2.206 - Entergy's Management of Spectra/Algonquin
Energy Natural Gas Transmission Lines within the
Site Boundary at Indian Point Nuclear Power Plants
(EDATS: OEDO-2010-0854)

October 25, 2010

SUBJECT: 10 CFR 2.206 Petition regarding Inadequacy of Entergy's Management of Spectra/Algonquin Energy Natural Gas Transmission Lines within the site boundary at Indian Point Nuclear Plants

Figure 5

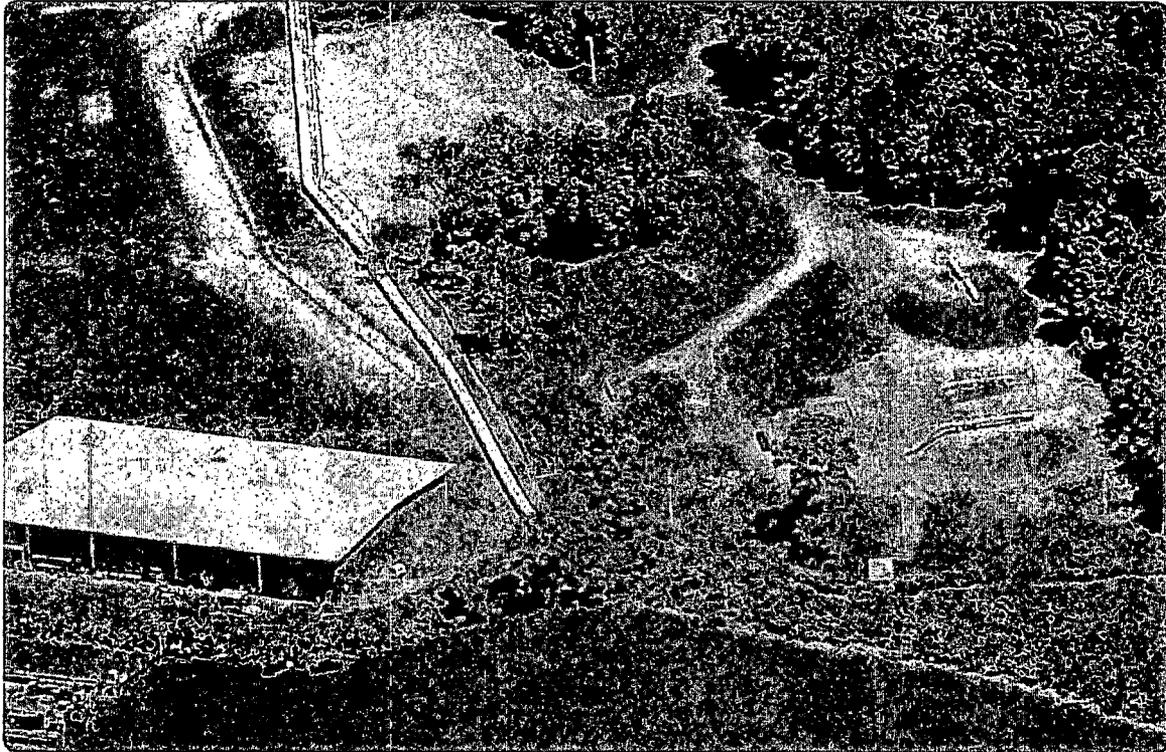
² Figure 5 clearly shows the gas lines exiting the Hudson River have little or no physical protection.
